Access Compliance Report

Public Rights-of-Way

Intersection ID: 45735	Main Street: REDWOOD VALLEY LN	Cross Street: COPPER LEAF LN	Location: SW
ADA ID: CFC289A39C9B	Ramp Type: PerpDiag	Initial Pass/Fail: Fail	Overall Compliance: No
		Severity Score: 10

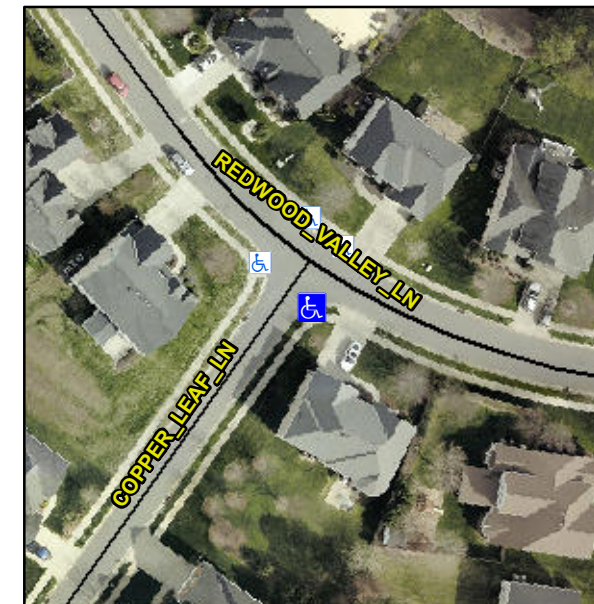
Not Found, R304.5.1, R304.5.3

Compliance	Description	Data	Compliance	Description	Data
N/A	Ramp Length (in)	47.0	Yes	Ramp Slope (%)	7.0
No	Ramp Width (in)	43.0	No	Ramp XSlope (%)	2.1
N/A	Flare Type LT	N/A	N/A	Flare Type RT	N/A
N/A	Flare Slope LT (%)	N/A	N/A	Flare Slope RT (%)	N/A
N/A	Flare Traversable LT?	N/A	N/A	Flare Traversable RT?	N/A
N/A	Landing Length (in)	N/A	N/A	DWS Provided?	N/A
N/A	Landing Width (in)	N/A	N/A	DWS Contrast?	N/A
N/A	Landing Slope (%)	N/A	N/A	DWS Length (in)	N/A
N/A	Landing X Slope (%)	N/A	N/A	DWS Full Width?	N/A
N/A	Landing Curb? (Y/N)	N/A	N/A	DWS Offset (in)	N/A
N/A	Shared Landing?	N/A			
N/A	Gutter Ponding?	N/A	N/A	Gutter Slope (%)	N/A
N/A	Gutter Lip Ht (in)	N/A	N/A	Gutter X Slope (%)	N/A
N/A	Painted X Walk1?	No	N/A	Painted X Walk2?	No
	X Walk 1 Direction	To NE		X Walk 2 Direction	To NW
N/A	X Walk 1 Width (in)	N/A	N/A	X Walk 2 Width (in)	N/A
	X Walk 1 Slope (%)	2.2		X Walk 2 Slope (%)	1.3
	X Walk 1 X Slope (%)	0.0		X Walk 2 X Slope (%)	3.1

Remove & Replace Curb Ramp With Two New Directional Ramps or Equivalent.
